World Forum for Harmonization of Vehicle Regulations

Proposal for Supplement 7 to the 01 series of amendments to UN Regulation No. 129 (Enhanced Child Restraint Systems)

Submitted by the Working Party on Passive Safety *

Figure 2
ECRS Measurement Device - Side and Front View of the measuring device

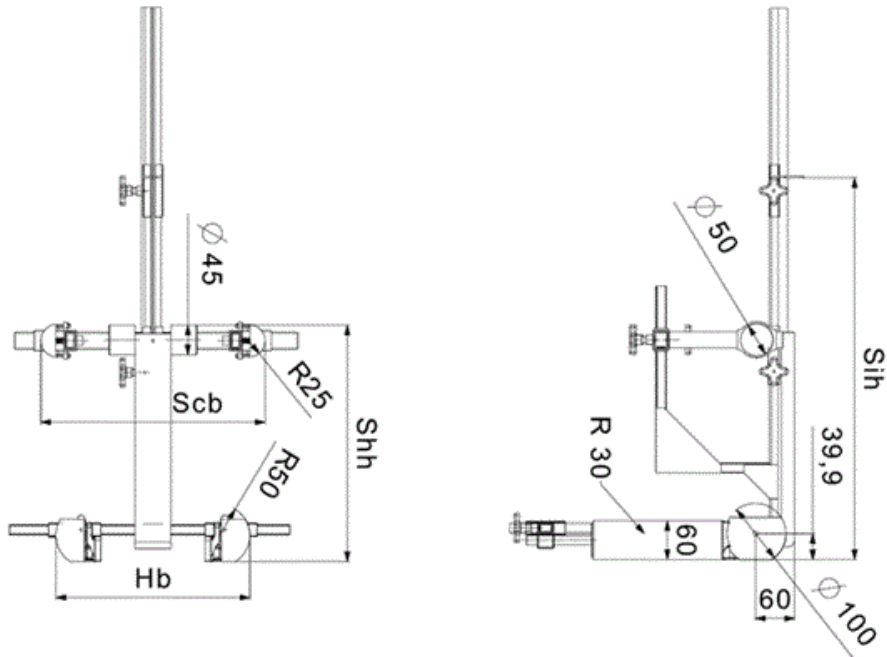
Annex 18., amend to read:

Geometrical dimensions of Enhanced Child Restraint Systems

For integral or non-integral ECRS the device shown in Annex 18, Figure 2 shall be used.

The mass of the devices described in Figure 2 and Figure 3 shall be 10 kg +/- 1 kg.

All measurements shall be taken with the device base in contact with the seat pan of the ECRS and the device backrest in contact with the backrest of the ECRS. All lateral dimensions shall be measured under a contact force of 50 N with the devices described in Figure 2 and Figure 3 of this annex.

Figure 3
Side and Front View of the measuring device for measurements applicable to Enhanced Child Restraint Systems that feature an impact shield

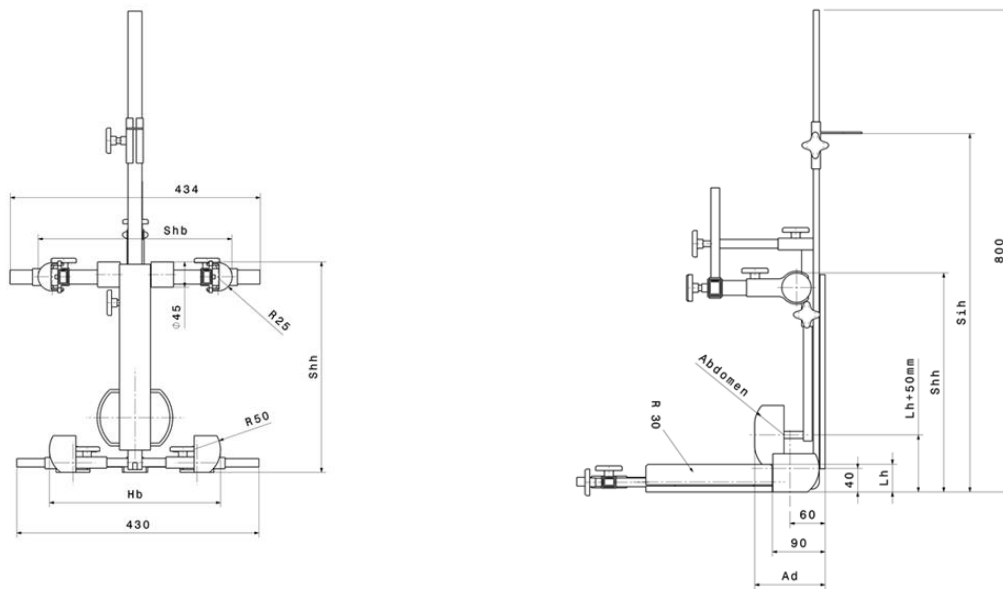
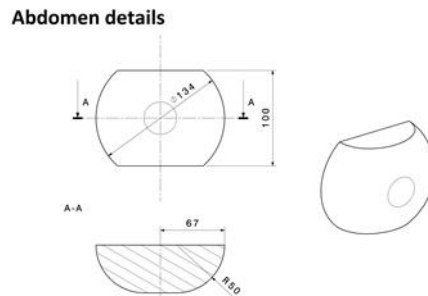
For ECRS with an impact shield the device shown in Annex 18, Figure 3 shall be used.
